# HISTORIC LANDMARK COMMISSION STAFF REPORT

**TRACY AVIARY OWL FOREST**  
PLNHLC2010-00645  
Liberty Park, 589 East 1300 South  
December 1, 2010

As part of an ongoing upgrade and renovation of the Tracy Aviary, the applicant, Friends of Tracy Aviary is requesting Historic Landmark Commission approval of 8 exhibit structures that will be used to house an interactive exhibit featuring owls.

DEMOLITION PLAN  
SCALE : 1"=10'-0"

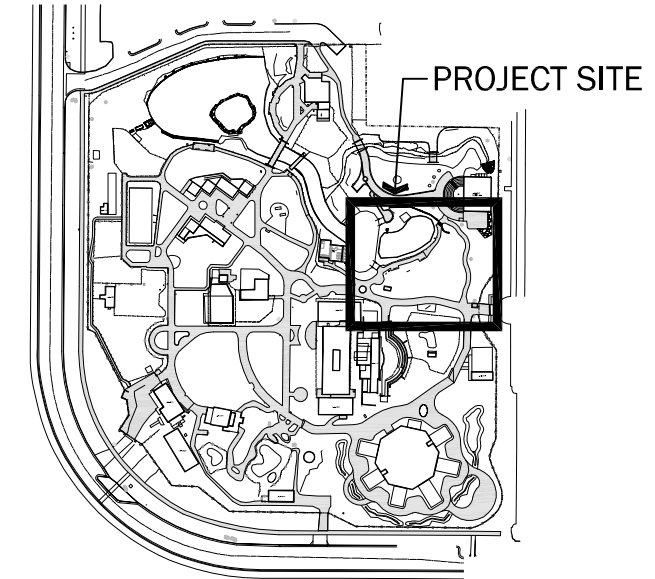
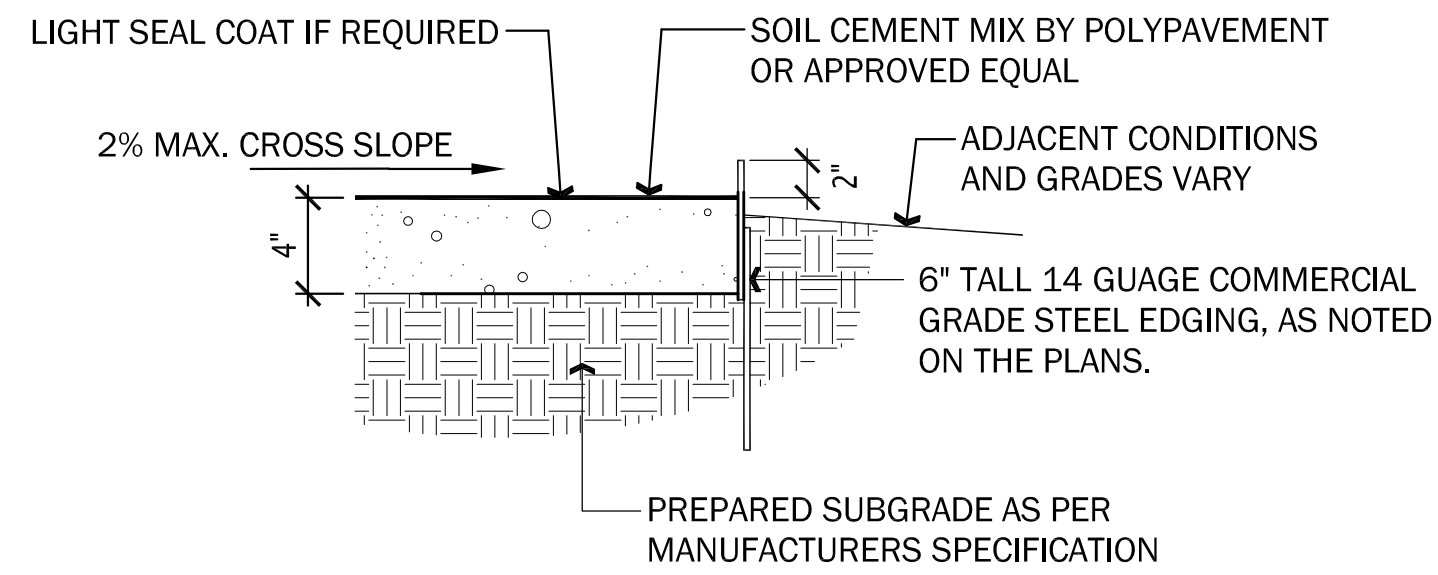
- With the exceptions noted below, the trees currently marked with ribbons are OK for removal as part of the upcoming infrastructure project.
- We are also OK to remove the 3 smallish elms, 2 junipers, and 2 mulberries from the Owl Forest area.

- \*\* 2 Hawthorns in Owl Forest area. [Owl Forest]
  - \*\* Magnolia in Owl Forest area. [Owl Forest]
  - \*\* Tri-color Beech south of the main bridge. [Infrastructure]

- **Peter B.** – update Phase 2B landscape/demo drawings to reflect additional tree transplants. The Owl Forest drawings are in good shape.
- **Matthew U. and Peter B.** -- identify locations within Aviary for transplanted trees. If we do not want them, let me know and I will alert Bill that they are available for placement elsewhere.
